NO.	DATE	DESCRIPTION
6	2018/04/11	ISSUED FOR ADDENDUM #4
5	2018/03/23	ISSUED FOR TENDER
4	2018/01/19	ISSUED FOR PERMIT REVISIONS
3	2017/12/19	ISSUED FOR BUILDING PERMIT
2	2017/03/22	ISSUED FOR COSTING
1	15/12/02	ISSUED FOR COORDINATION

PROJECT:  
**BROCK MISSION  
MEN'S SHELTER**

DRAWING TITLE:  
**FLOOR PLANS**

DRAWING NO:  
**A-102**

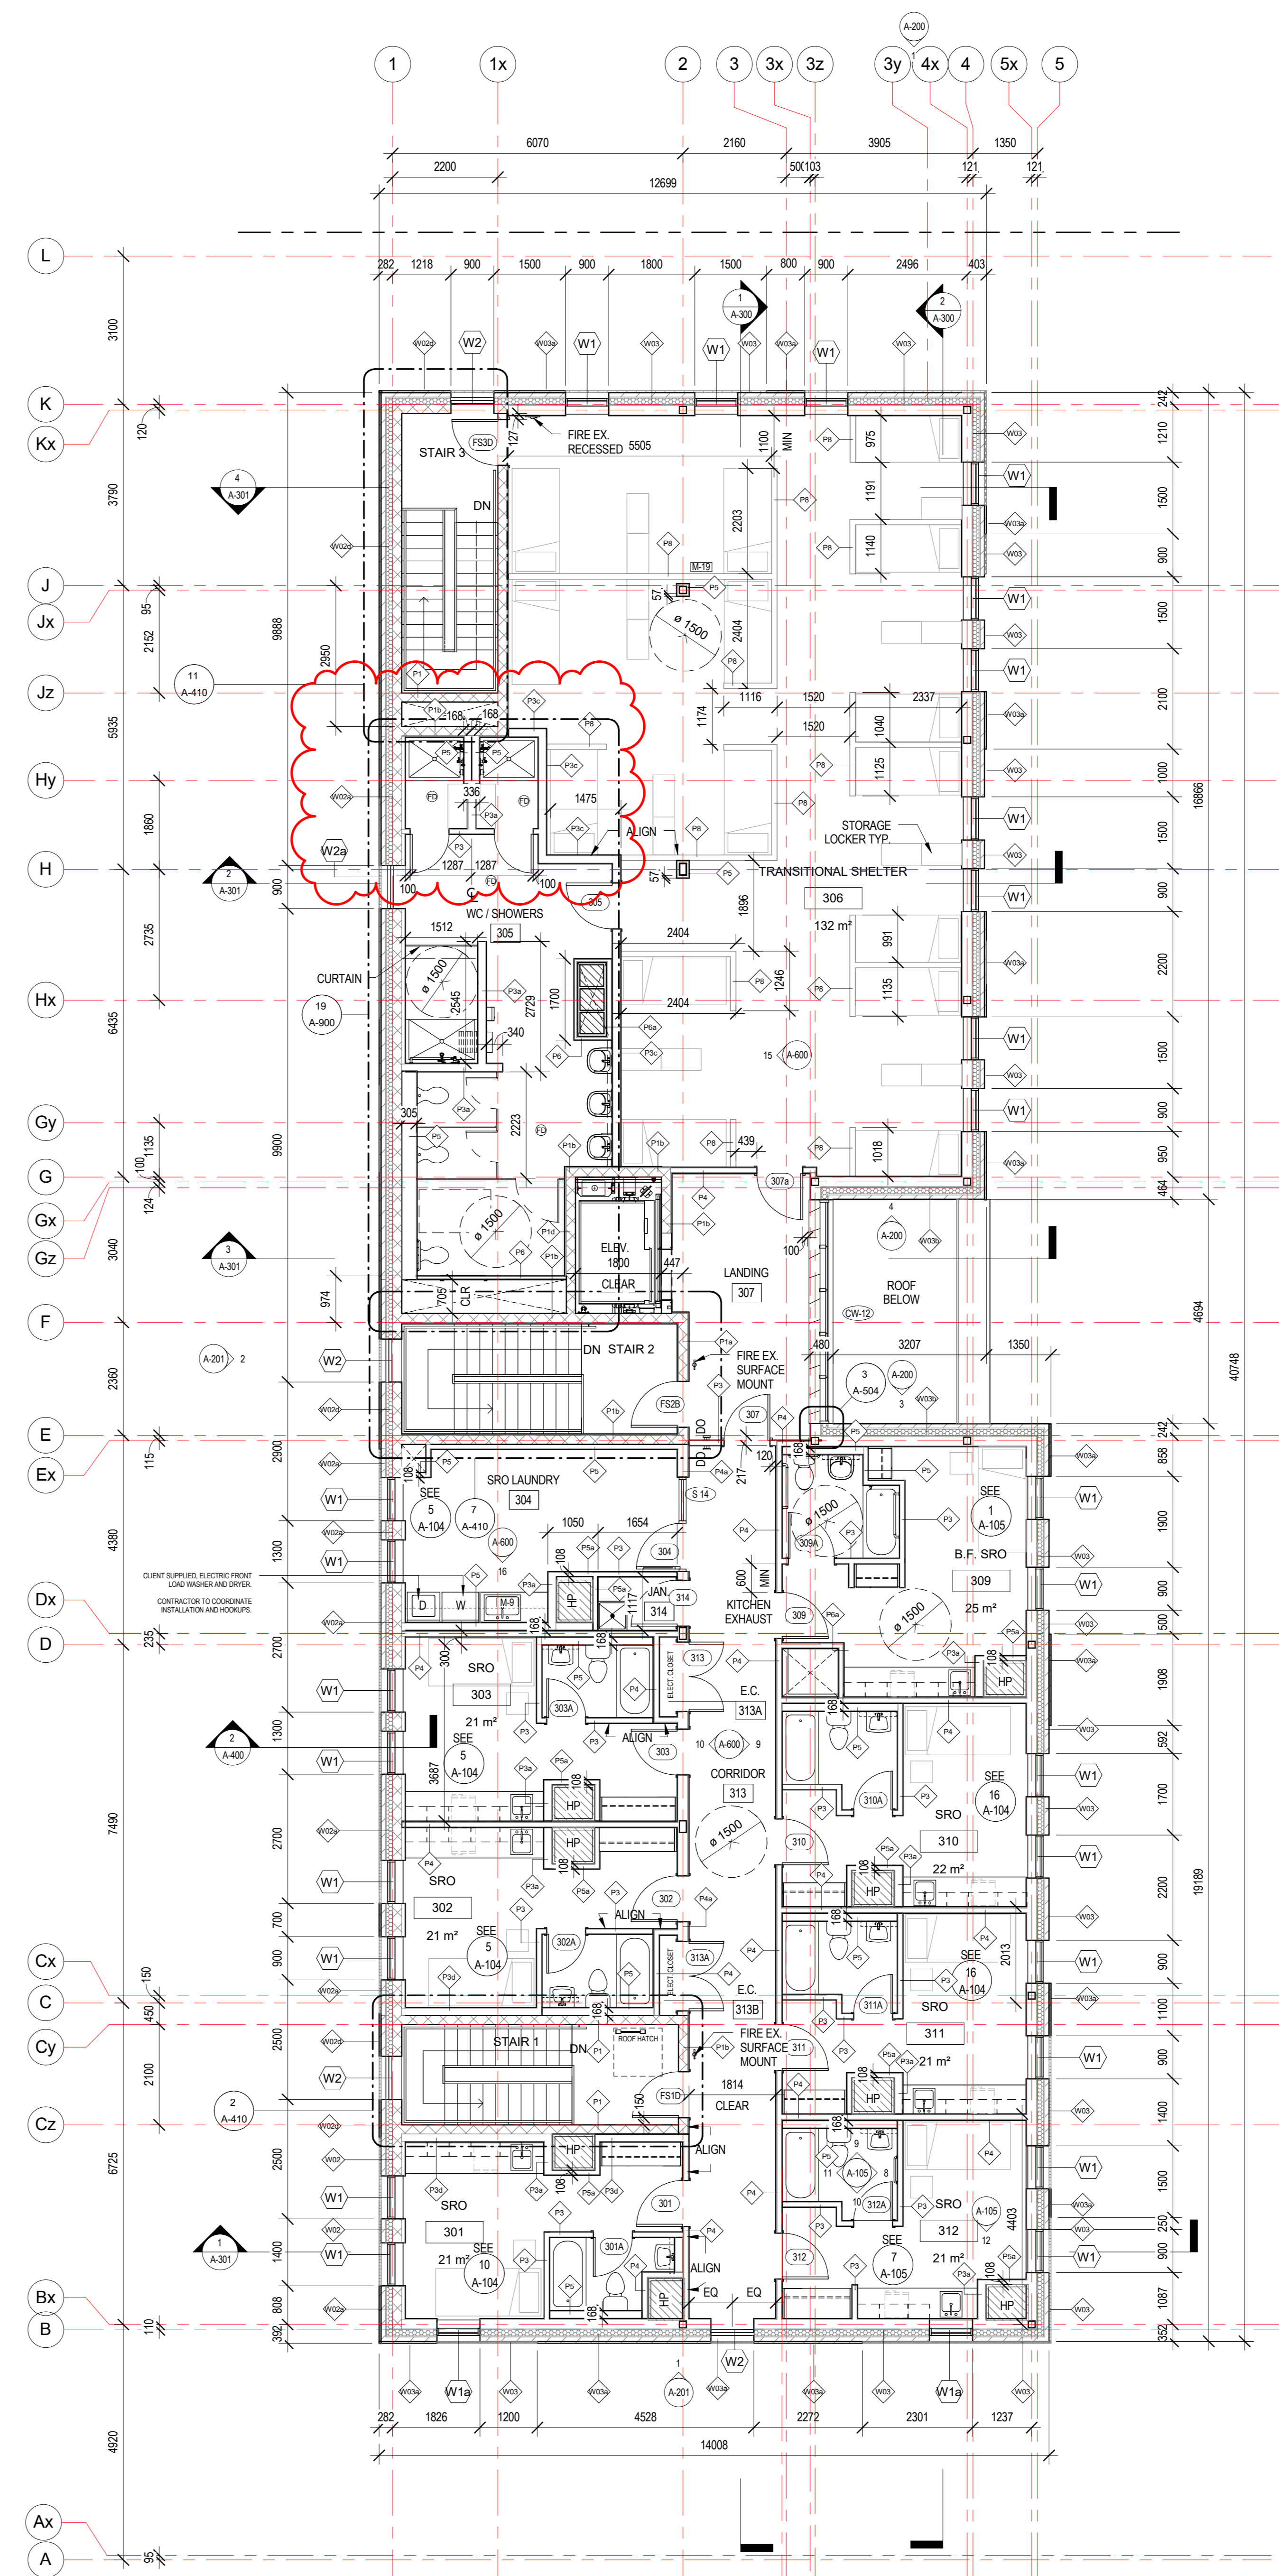
NOTE:  
REFER TO ELEVATIONS FOR CHANGE IN EXTERIOR BRICK ASSEMBLY
